# MONITORING YEAR 2 ANNUAL REPORT

## SHAKE RAG MITIGATION SITE

Madison County, NC  
DEQ Contract No. 7190  
DMS Project No. 100018  
USACE Action ID No. SAW-2017-01570  
DWR Certification No. 17-1157

RE: Shake Rag Mitigation Site – Monitoring Year 2 Report Response to DMS Comments  
French Broad River Basin – CU# 06010105 – Madison County  
DMS Project ID No. 100018  
Contract # 7190

Figure 3.1 Monitoring Plan View Map  
Shake Rag Mitigation Site  
DMS Project No. 100018  
Monitoring Year 2 - 2021

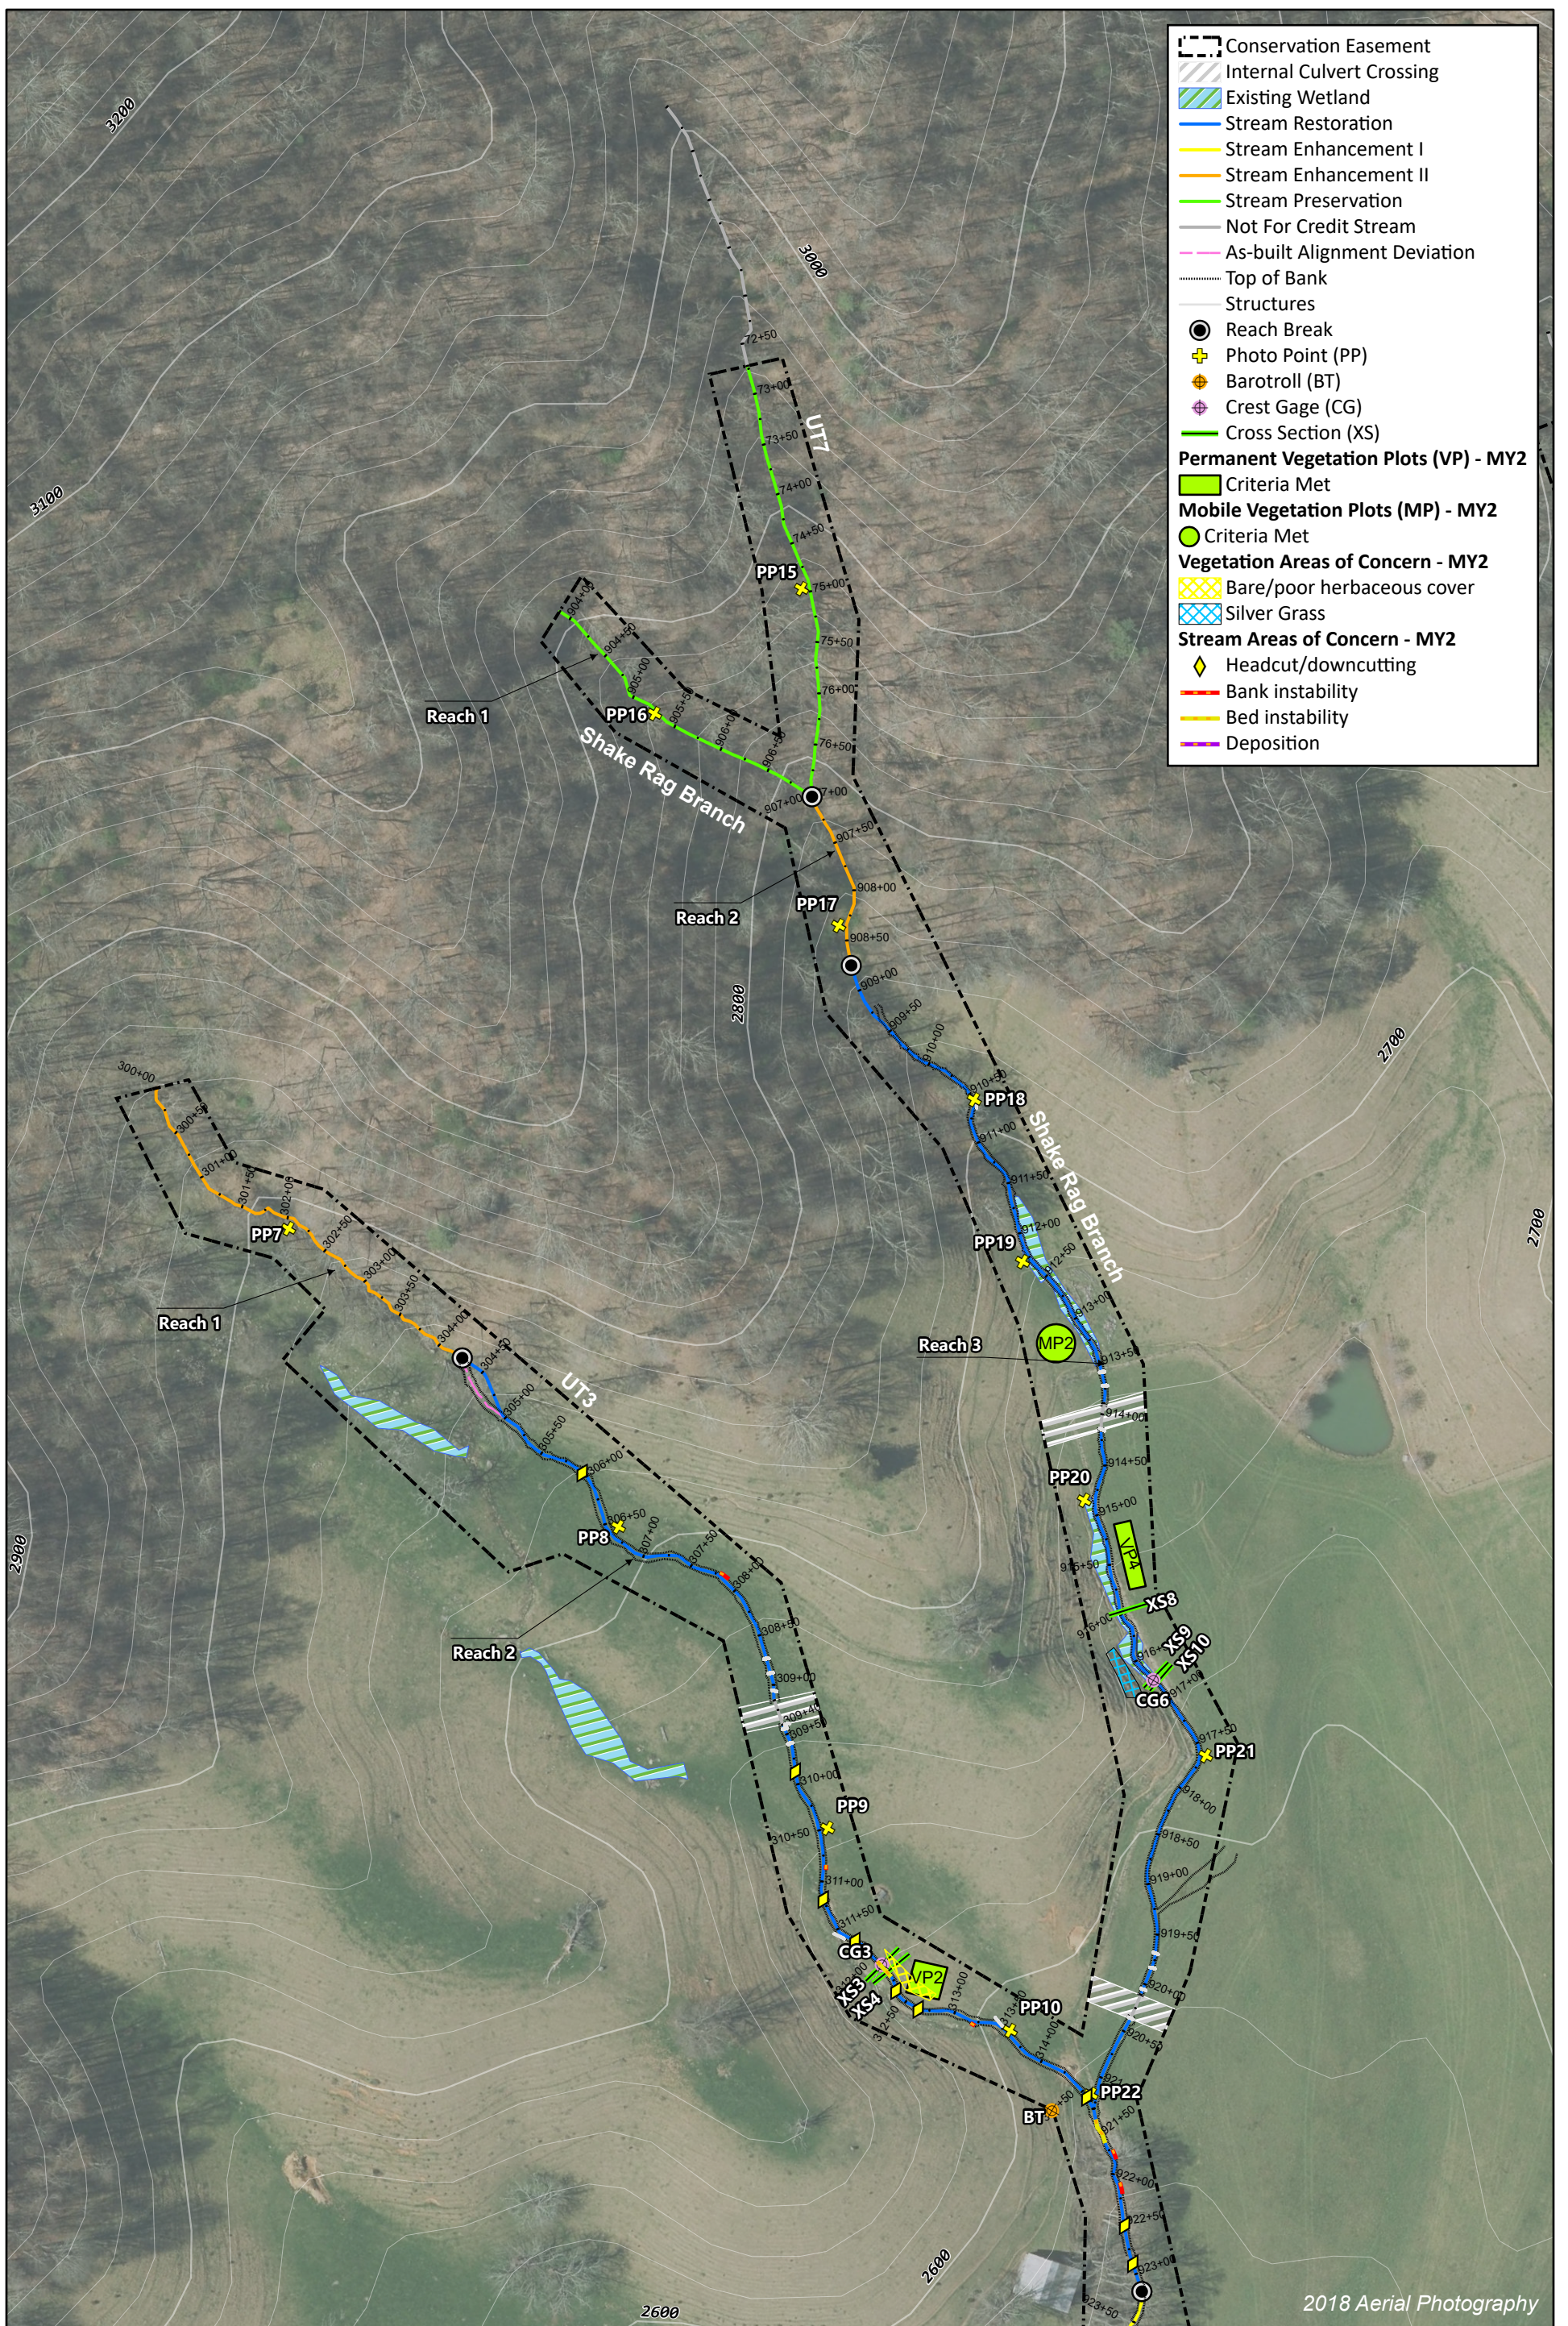
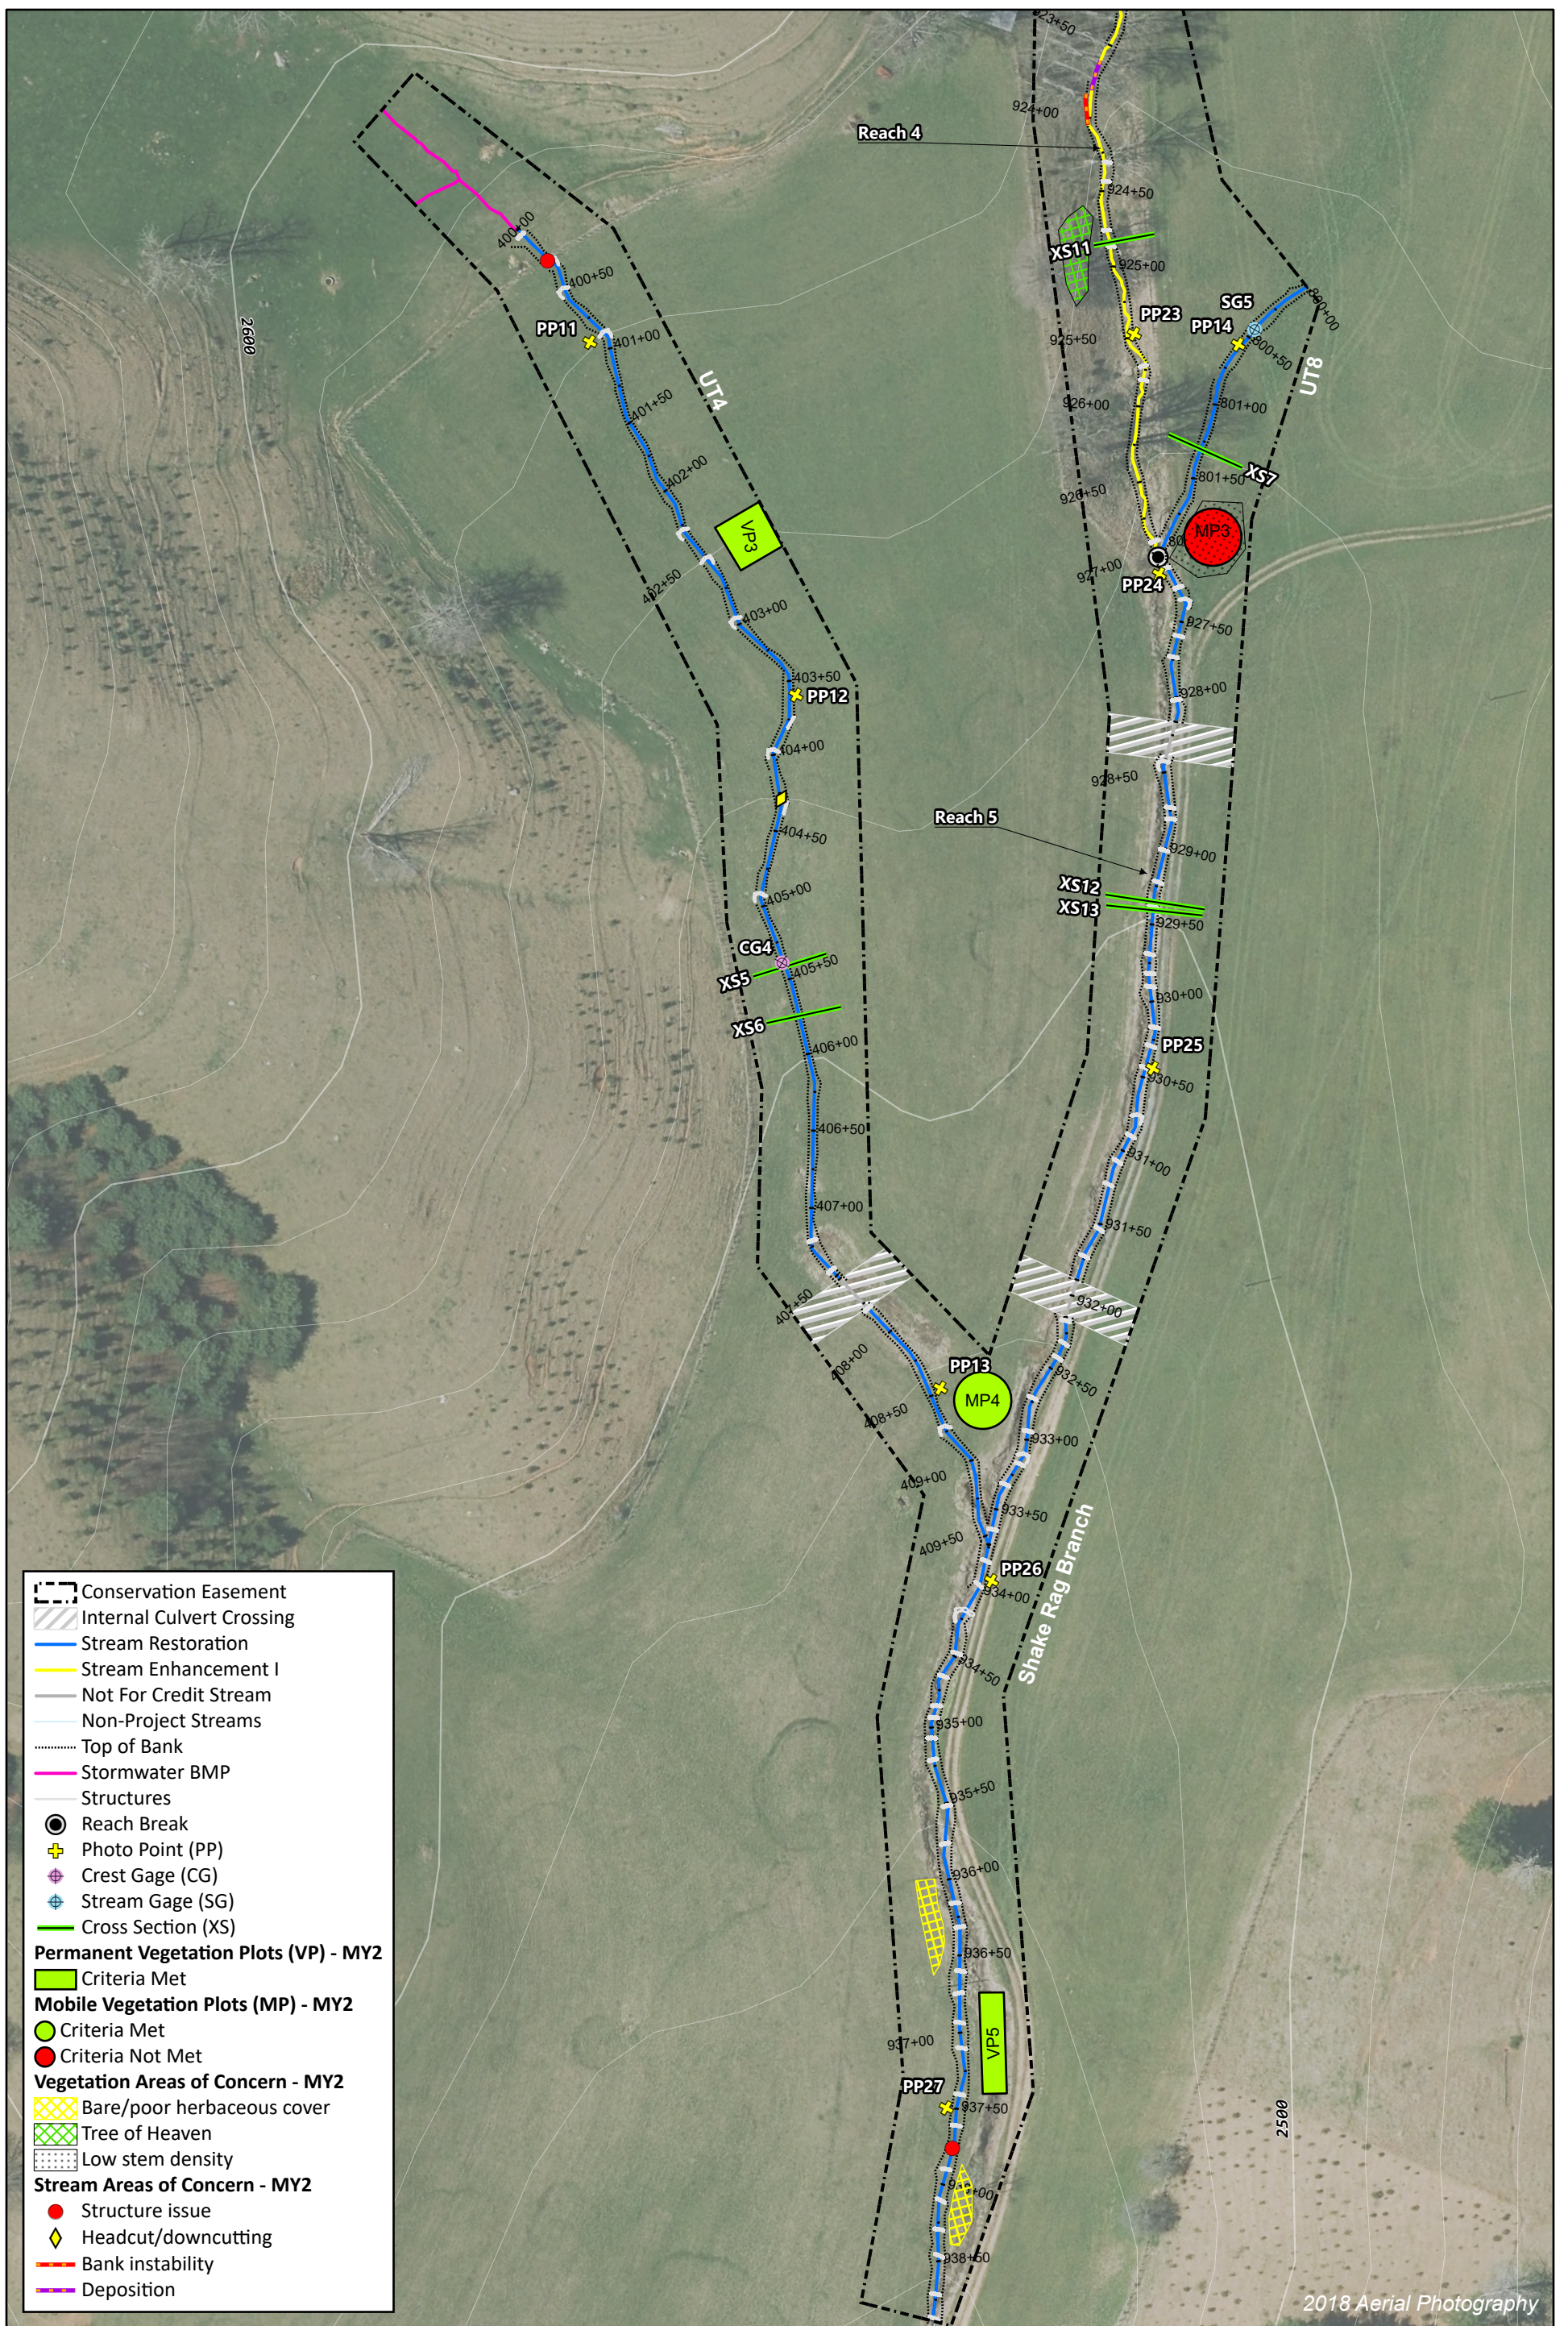
**DMS' comment: Section 1.2.5 should describe and reflect what is shown on the CCPV. Please revise this section with the level of detail necessary to inform reviewers of site conditions. Please quantify and describe problem areas. Include number, locations, type (rock/log) of piping structures, length and locations of eroding banks, etc. The text describes "reconfiguring boulders and riffle stone around problematic structures", but Table 6 lists engineered structures as functioning at 100% the majority of the time. Please review and revise the CCPV and Table 6 as necessary.**

**DMS' comment: There are 11 headcuts shown on the CCPV and not discussed in the report. Please add a discussion of these areas in the report.**

*Wildlands' response: Text has been added to Section 1.2.5 to better quantify and describe the areas of concern. An additional appendix (Appendix 6) has also been added with a table summarizing locations, type, length (if applicable), and planned management activity by stream reach. The majority of the issues identified as "headcut/downcutting" on the CCPV figures are located within sections of cascading riffles (as shown on the Shake Rag Record Drawings from as-built) that include many drops and riffles. Therefore, a few instances of "headcut/downcutting" associated with structures within the cascading riffle sections did not seem to warrant the failure of the entire cascading riffle since it's counted as one structure in the engineered structures category in Table 6.*

*Wildlands' response: Text has been added to Section 1.2.5.*
